CONTINUED PUBLIC HEARING MEMORANDUM

PETITION #119-15

28 AUSTIN STREET

Request for Special Permit/Site Plan Approval to redevelop a municipal parking lot with a mixed-use building and 127 public parking stalls

Figure 9: Existing Peak Hour Vehicle Volumes – Saturday Peak

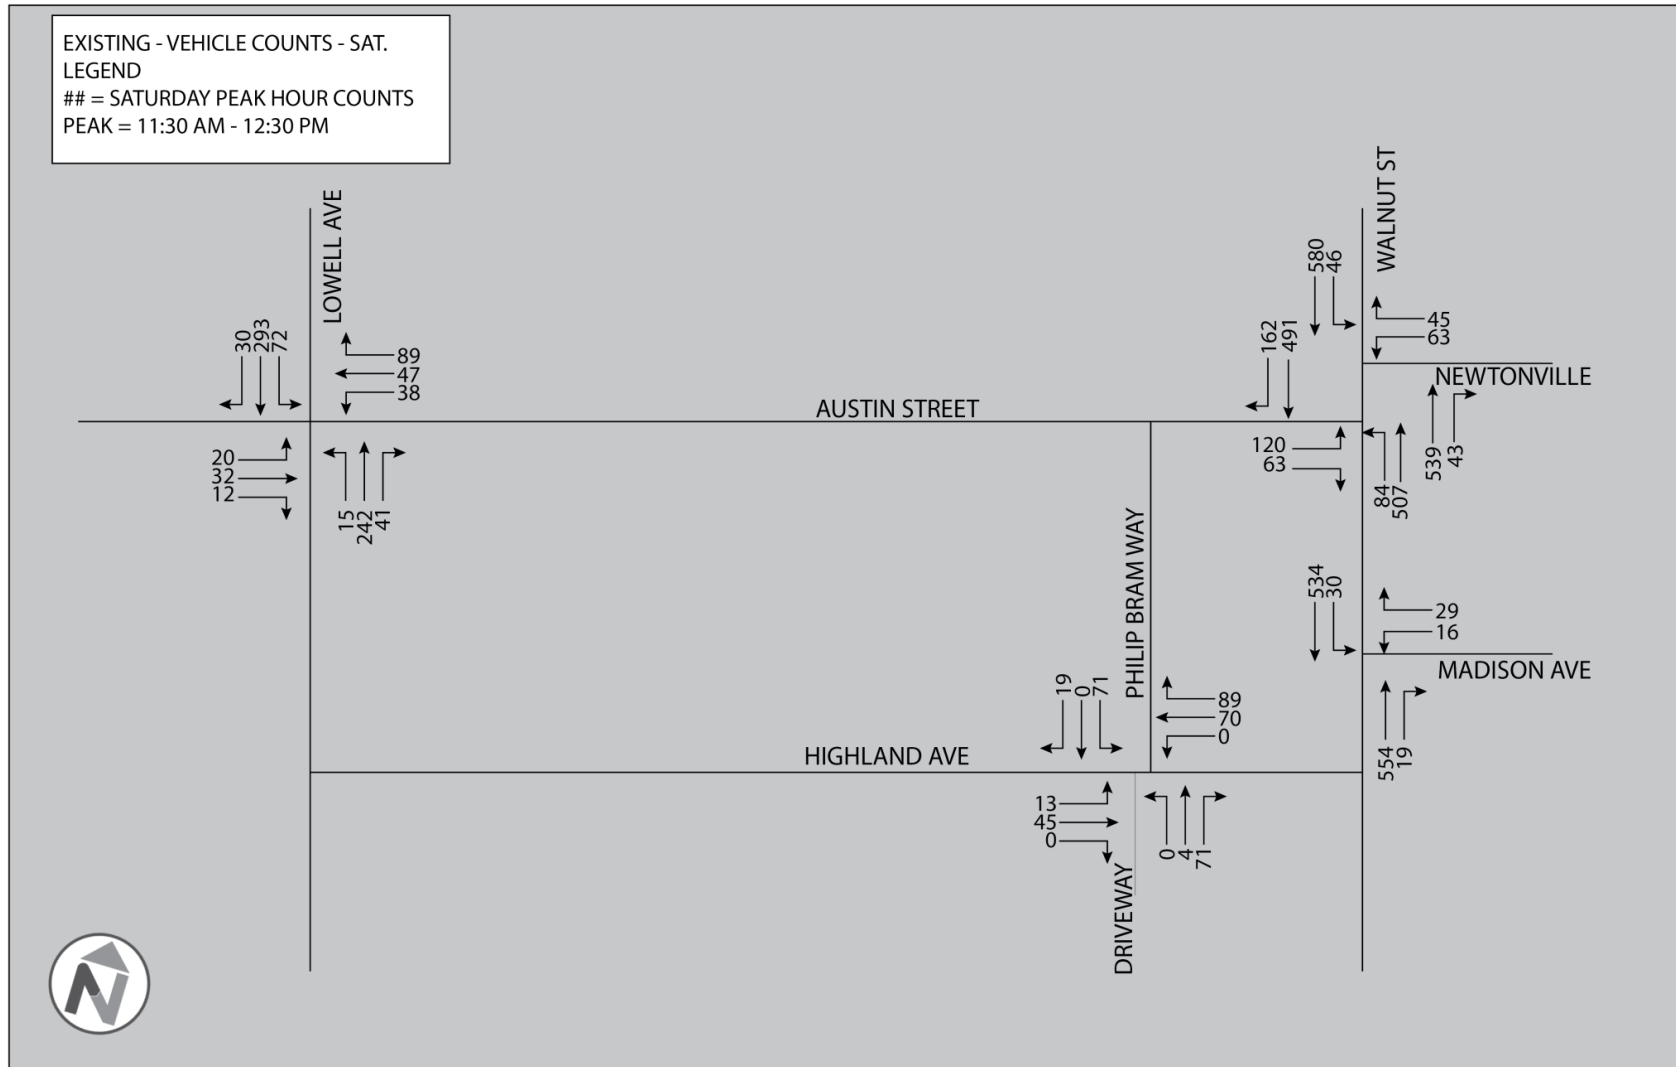
VAI Comment: The Applicant’s engineer should review the Saturday midday peak-hour traffic volumes at the Walnut Street/Newtonville Avenue intersection as it appears that the northbound right-turn volume should be 88 vehicles vs. 43 vehicles as shown on Figure 9. In addition, the associated traffic operations analyses should be revised accordingly.

NN Response: The through volumes from Austin Street to Newtonville Avenue were added to the northbound right turn movement to equal 88 vehicles. The revised traffic operations analyses are below and show that the increase in volumes did not change the overall level of service or delay.

Figure 13: Vehicle Trip Distribution – Weekday Peak

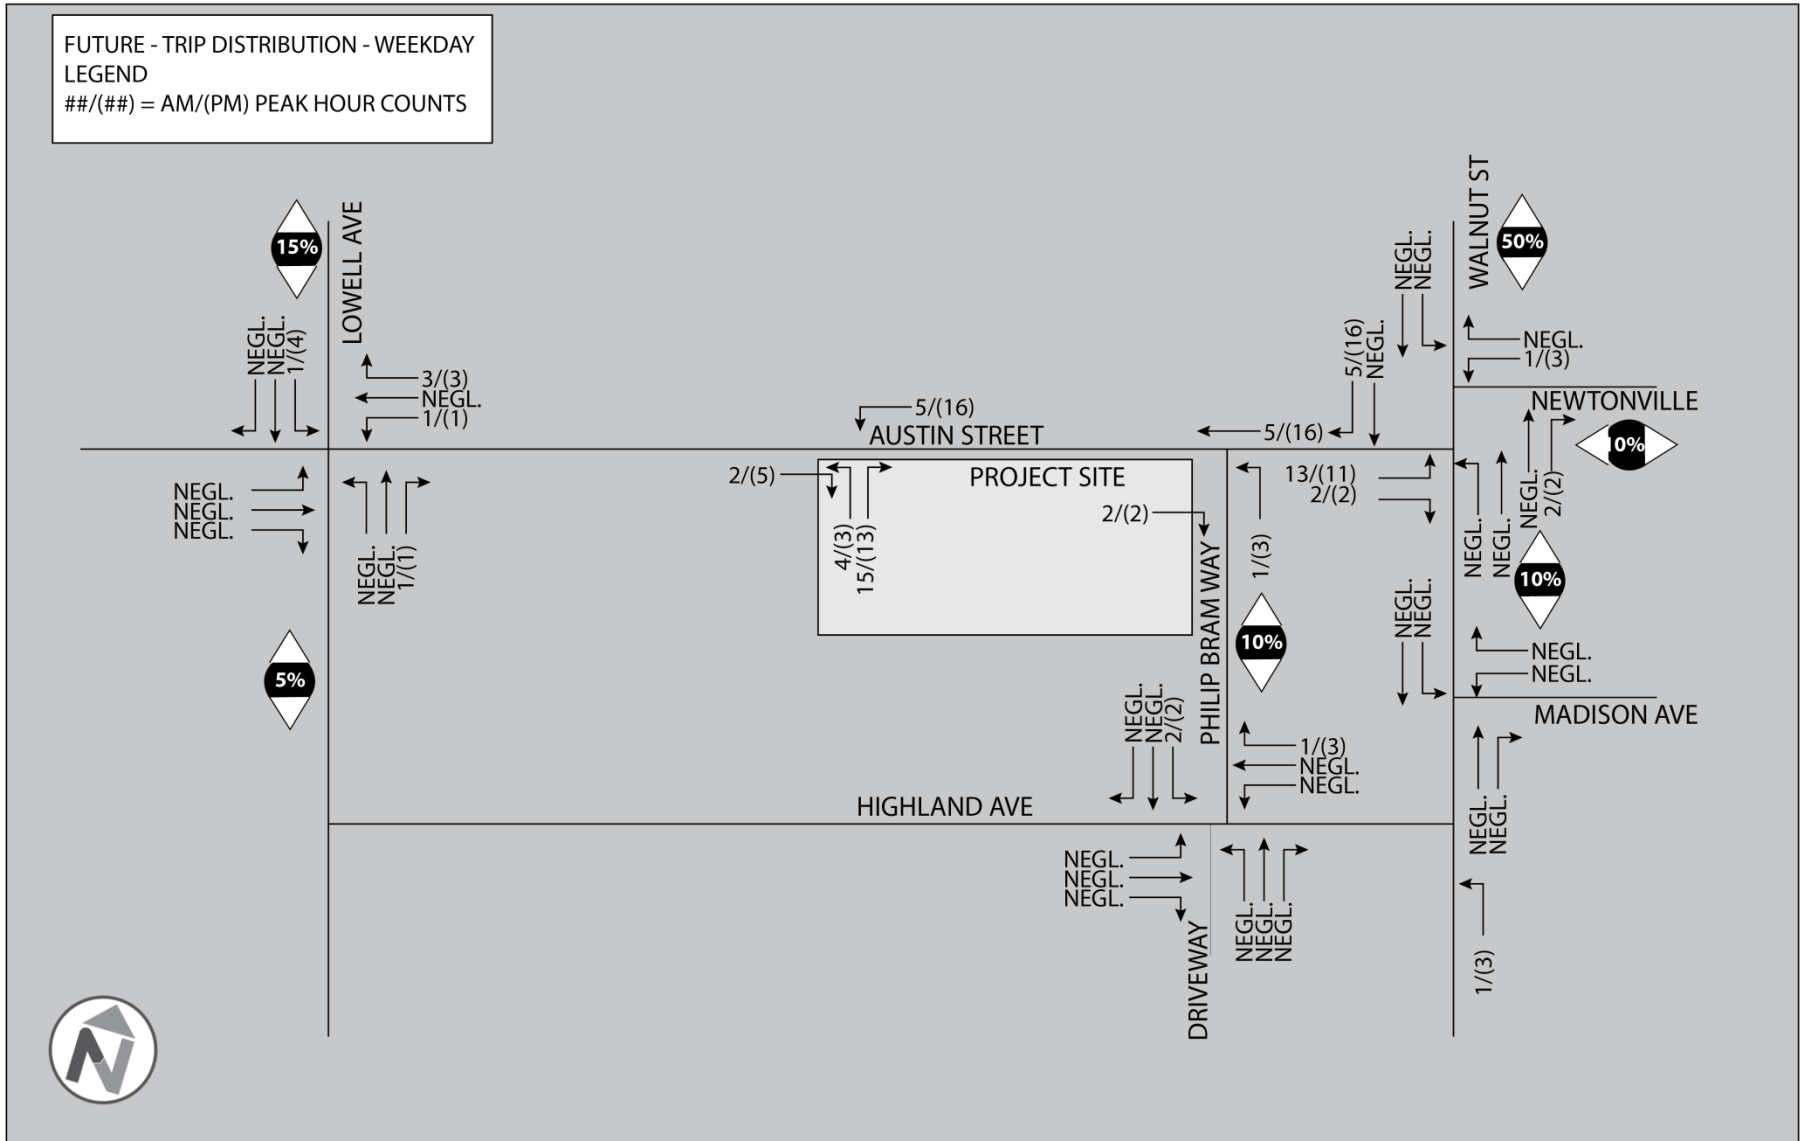
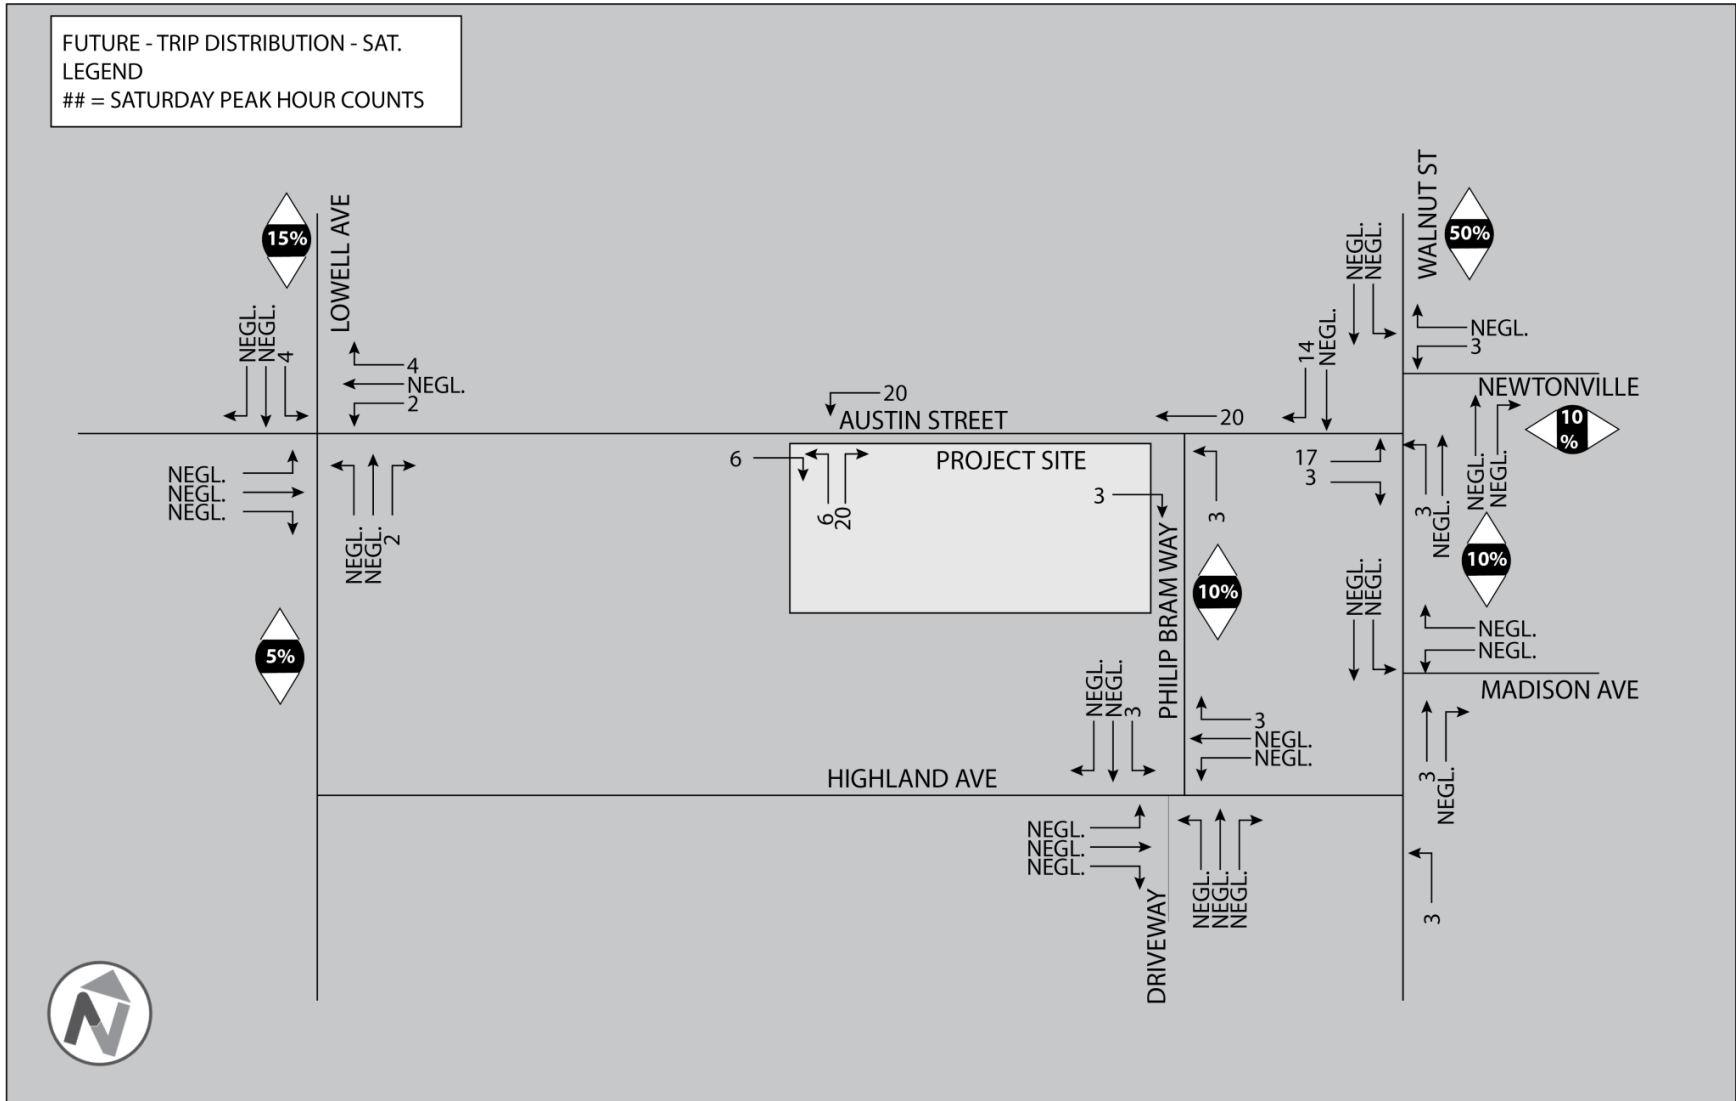
VAI Comment: We are in general agreement with the methodology that was used to develop the anticipated traffic characteristics of the Project, and concur with the methodology that was used to assign Project-related traffic onto the roadway network (existing traffic patterns); however, we were not able to validate the projections based on the information that was provided in the May 2015 TIS. **The Applicant's engineer should provide the back-up calculations for the information presented in Table 8, including the base ITE trip calculations, the mode split that was used to disseminate the ITE vehicle trips to the available modes of travel (auto, transit and walk) and the reconstitution of auto person trips to vehicle trips. In addition, the Applicant's engineer should review the resultant calculations and compare the reported values to those shown on Figures 13 and 14.**

NN Response: The information presented in Table 8 was derived from the ITE Trip Generation Manual 9th Edition as well as the 2013 U.S. Census 5-year mode share estimates. The calculations are included as an attachment to this memorandum.
